CHAPTER 343, HRS
Environmental Assessment/Determination
Negative Declaration

Recorded Owner/
Applicant : Daren Truitt
Agent : KT DESIGN GROUP
Location : 68-139 Au Street - Waialua
Tax Map Key : 6-8-11: 44
Request : Shoreline Setback Variance
Proposal : To construct a 4.5-foot high vinyl
safety fence within the shoreline
setback
Determination : A Negative Declaration is issued.

SHORELINE AREA VARIANCE FOR THE TRUITT RESIDENCE

SUBJECT: Draft Environmental Assessment (DEA) for a Shoreline
Setback Variance (93/SV-9): Truitt Safety Fence,
Wailua, Oahu, TMK: 6-8-11: 44

SITE PLAN - PROPOSED FENCE
 (REVISED OCT. 6, 1993)
 EXHIBIT B

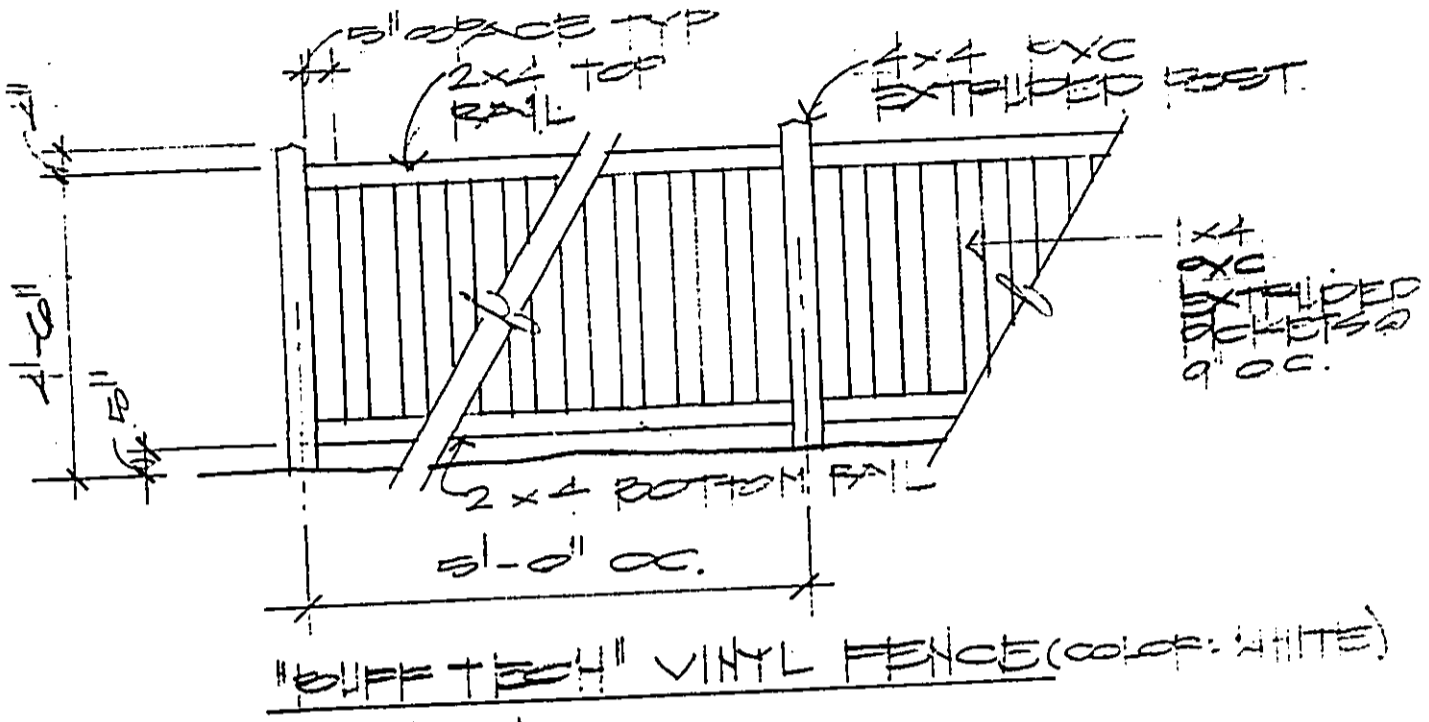
The Division of State Parks comments that there is a discrepancy in the depth of the property, 117.01' in the proposed site plan versus 110.00' in the certified shoreline map.

However, if these distances reflect the depth of the parcel to the shoreline, then the proposed fence, as indicated in the Site Plan (Exhibit B), would be located within Conservation District and subject to Conservation District regulations.

In regard to the comment made by the Division of State Parks concerning the discrepancy in the depth of the property, the dimension of 117.01' is to the Certified Shoreline. The 110.00' dimension is measured from the S.W. corner of the property to the 1/2" pipe located in the N.W. area of the site. The extra 7.01' is from that pipe to the Certified Shoreline.

The answer to the Office of Conservation and Environmental Affairs concern is that the distances of 110.00' and 107.54' are measured to the 1/2" pipe markers, and not to the Certified Shoreline.

CERTIFIED SHORELINE MAP

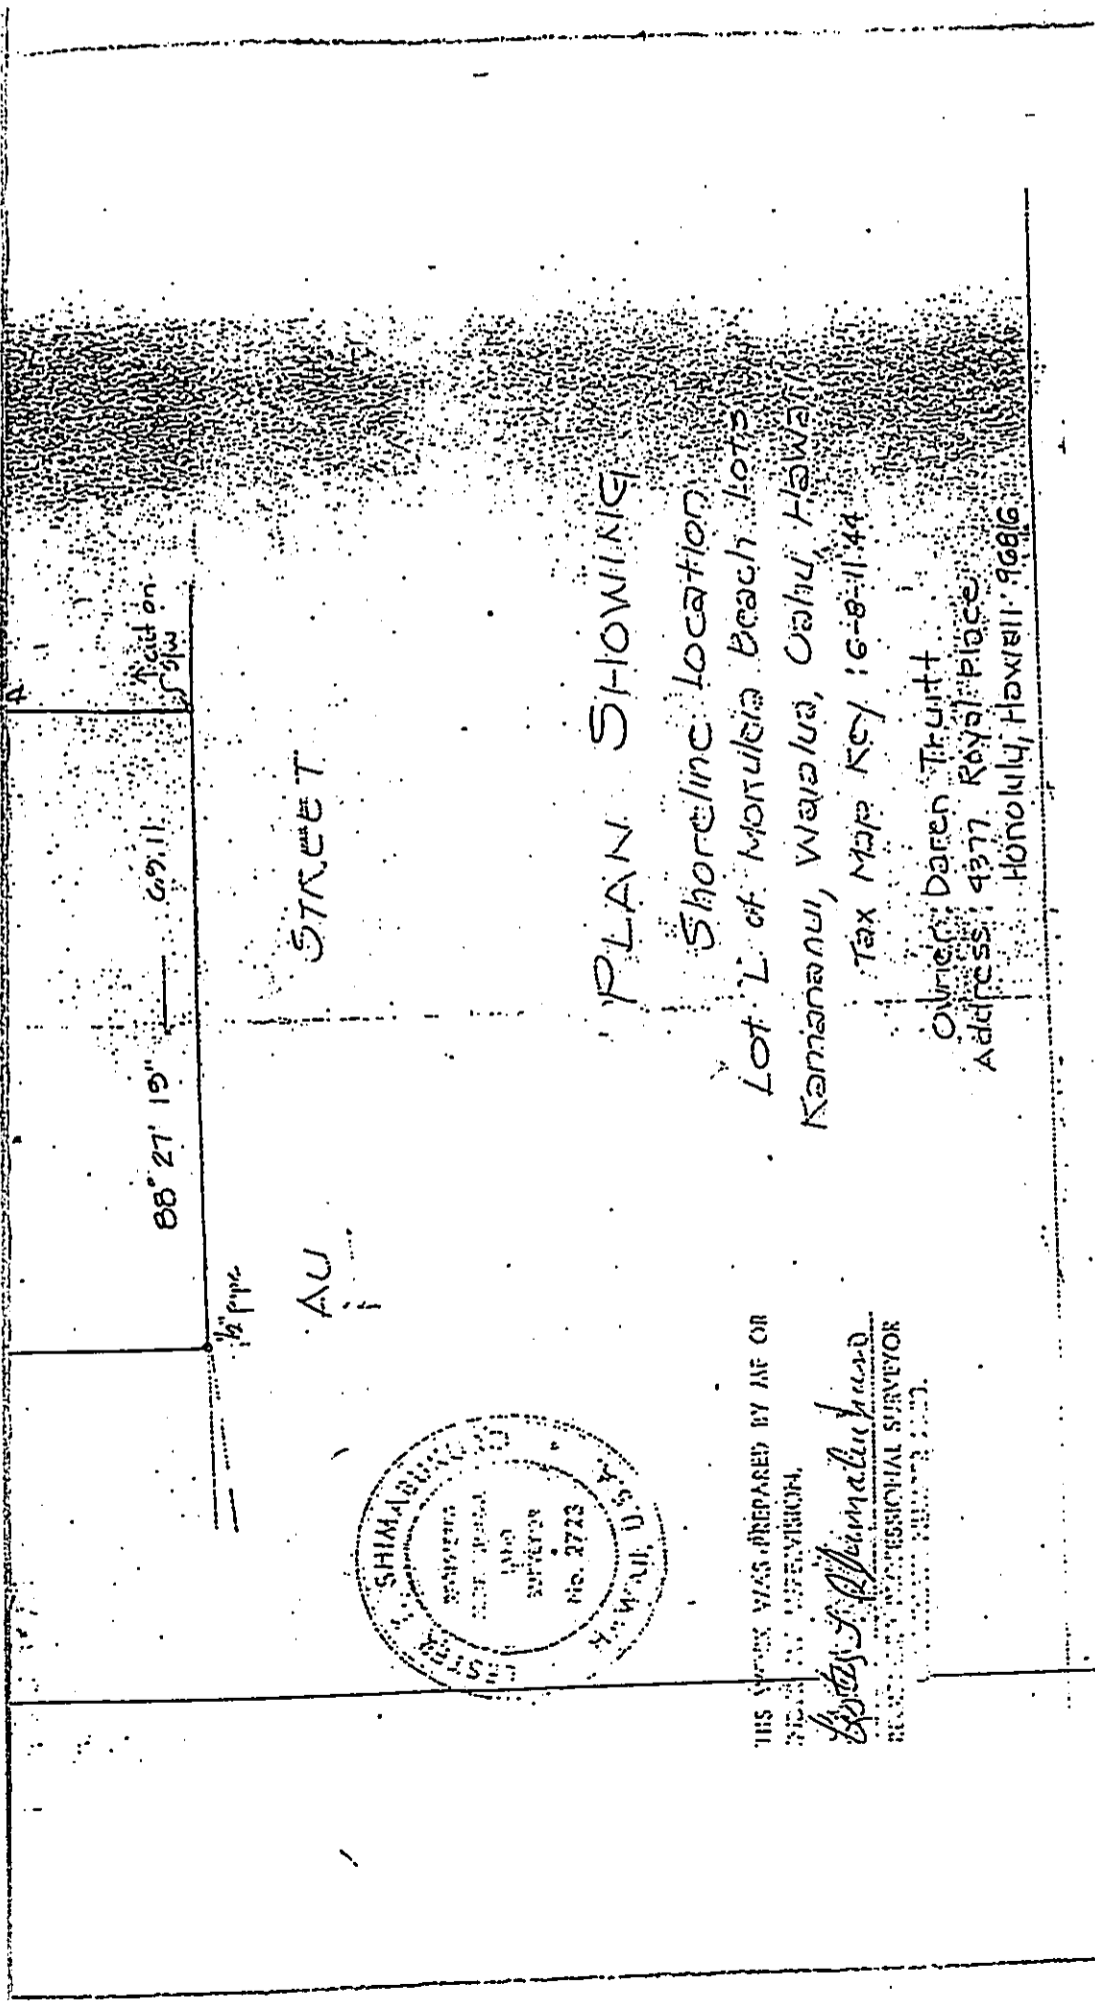
The Office of Conservation and Environmental Affairs comments that if the 110.00' and 107.54' distances on the Certified Shoreline Map (Exhibit D) reflect the depth of the lot to the 1/2" pipe markers, and not the distances to the Certified Shoreline, they have no objections to the proposed project.
